### Harrisville City Planning Commission Harrisville City Offices Wednesday, November 9, 2022 – 7:00 p.m.

## MEMORANDUM

RE: **BEN LOMOND PHASE 2-D SUBDIVISION**  
**Preliminary Plat Submittal**

Our office has completed a review of the preliminary plat and improvement plans for the Harrisville Fields Subdivision located in between North Harrisville Road and 400 North at approximately 375 West. The development is a cluster development and includes 51 single family homes and a large open space area. The Developer is proposing to break up the development into two phases but is requesting preliminary approval of the overall site at this time. If preliminary approval of the entire subdivision is granted, then they will come back to receive final approval for each individual phase.

UTILITY PLAN

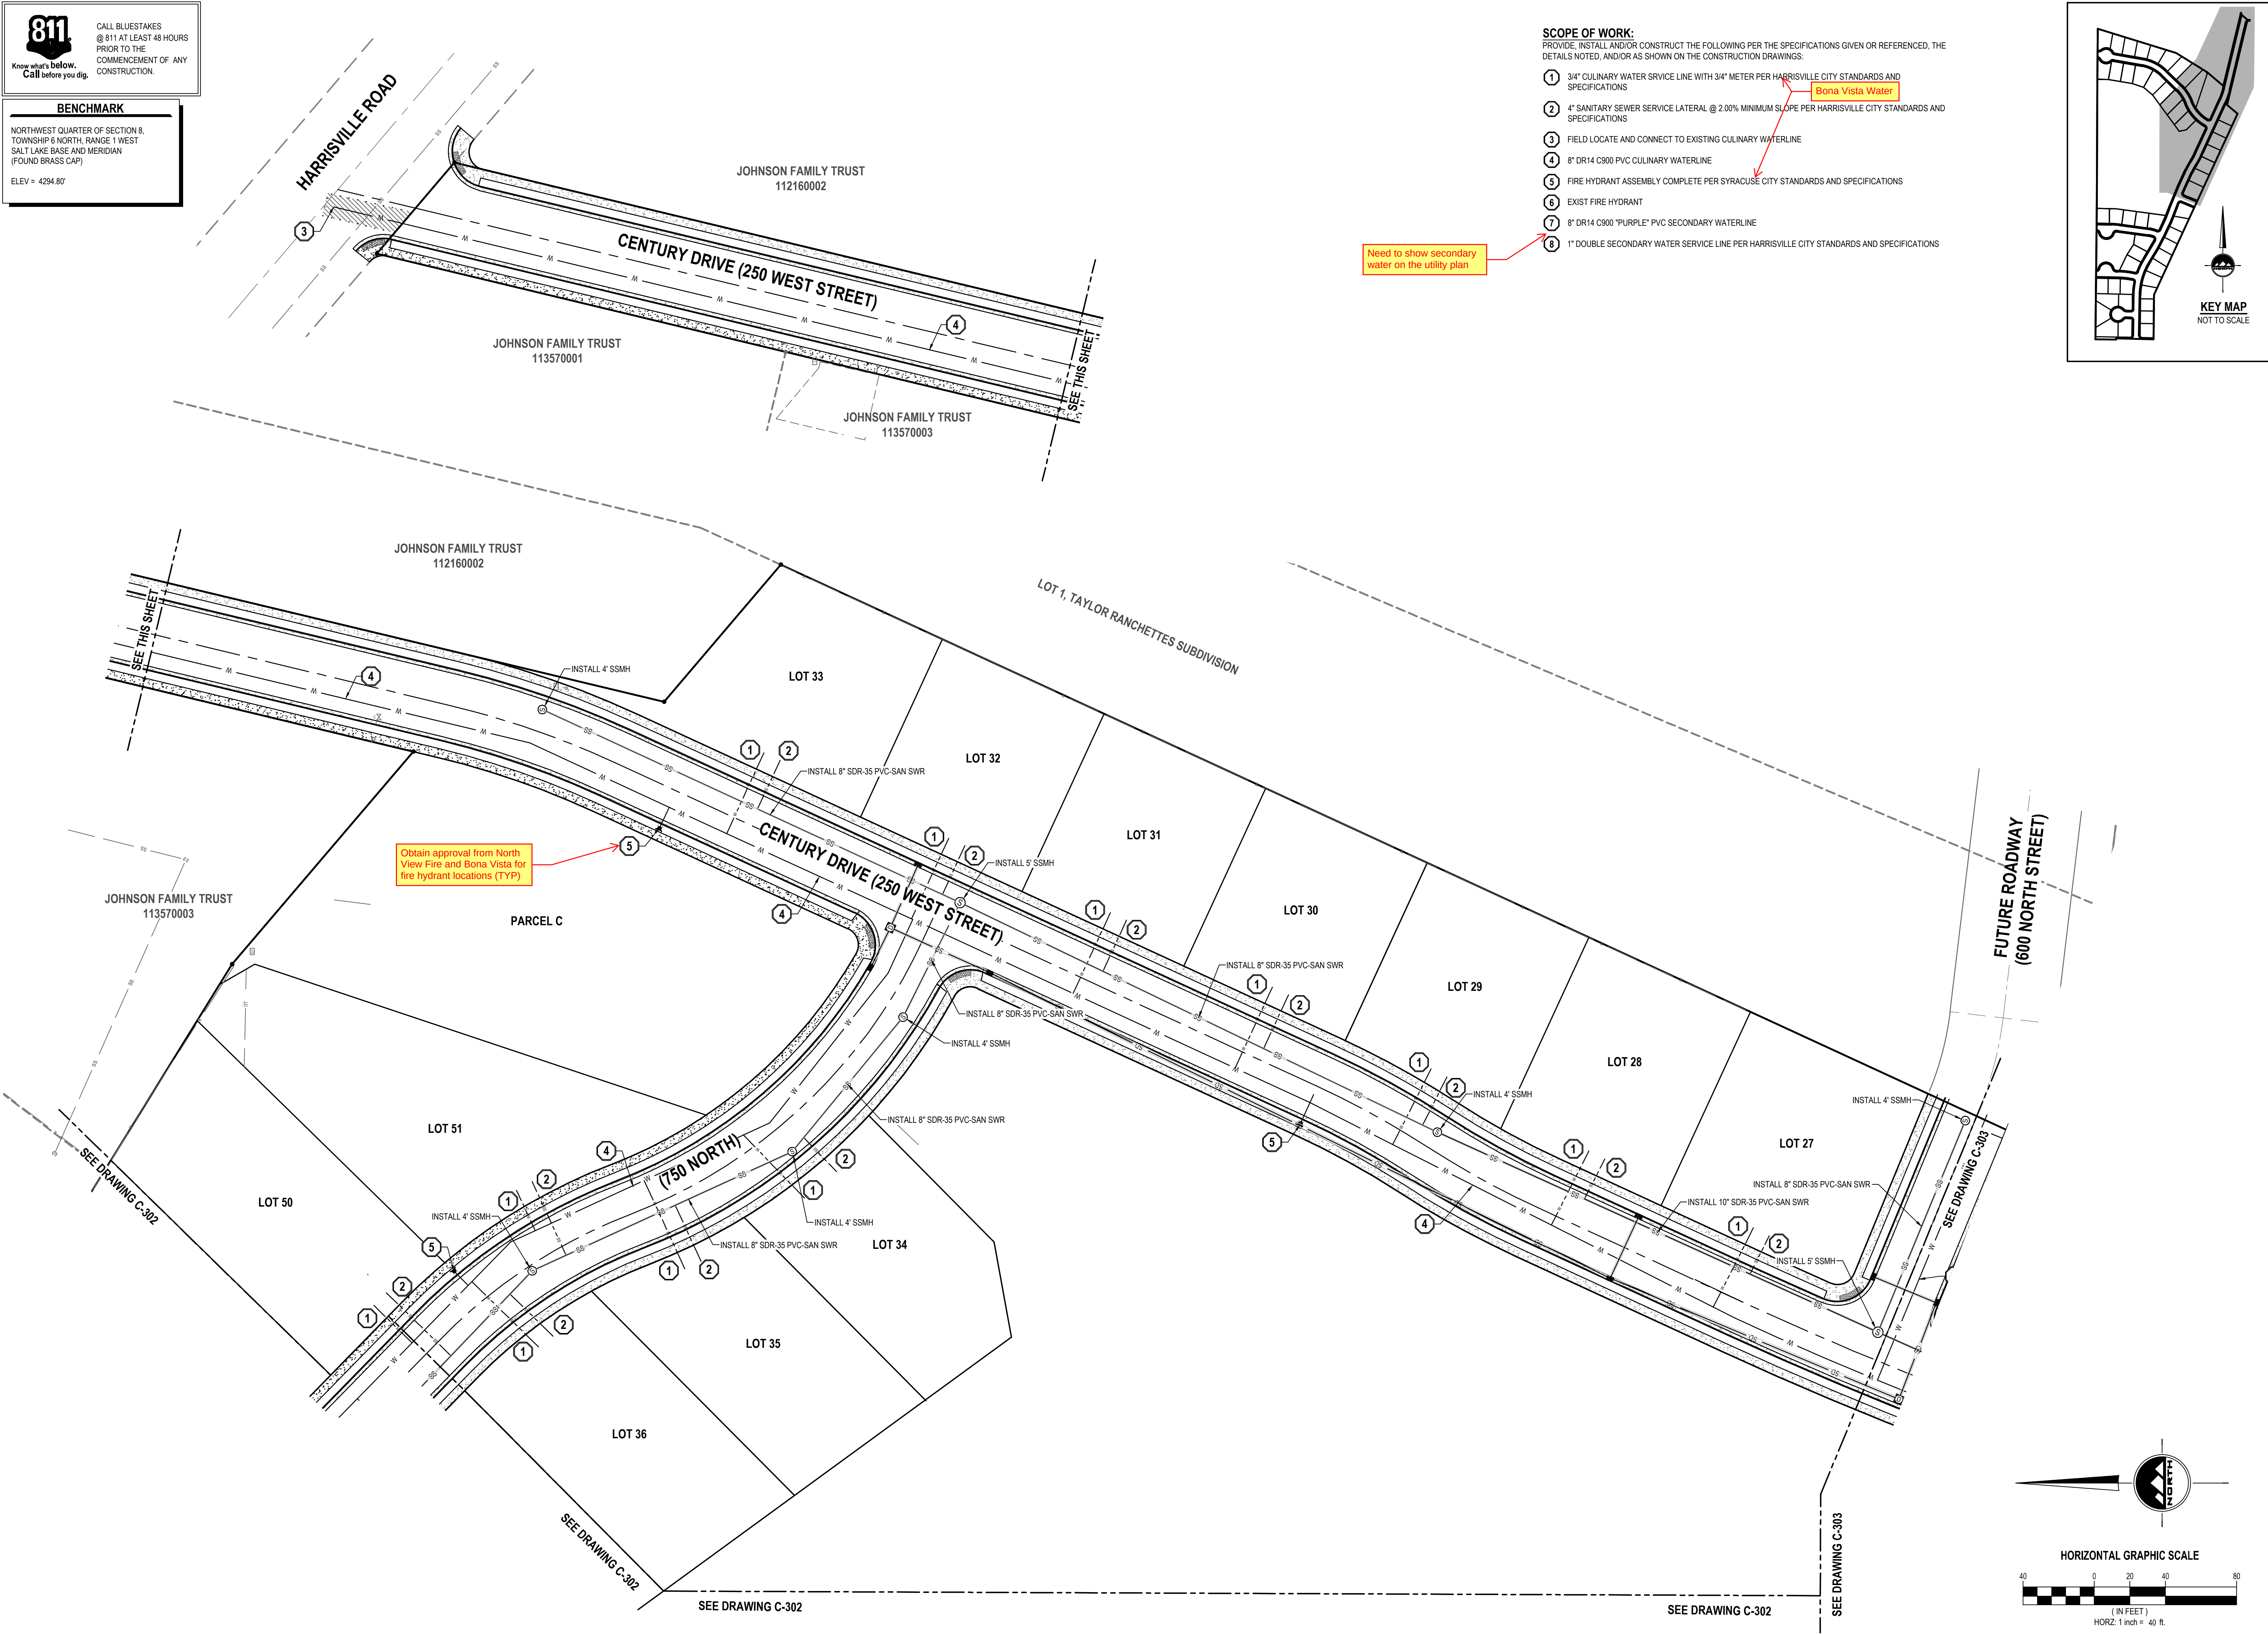
Need to show secondary water on the utility plan
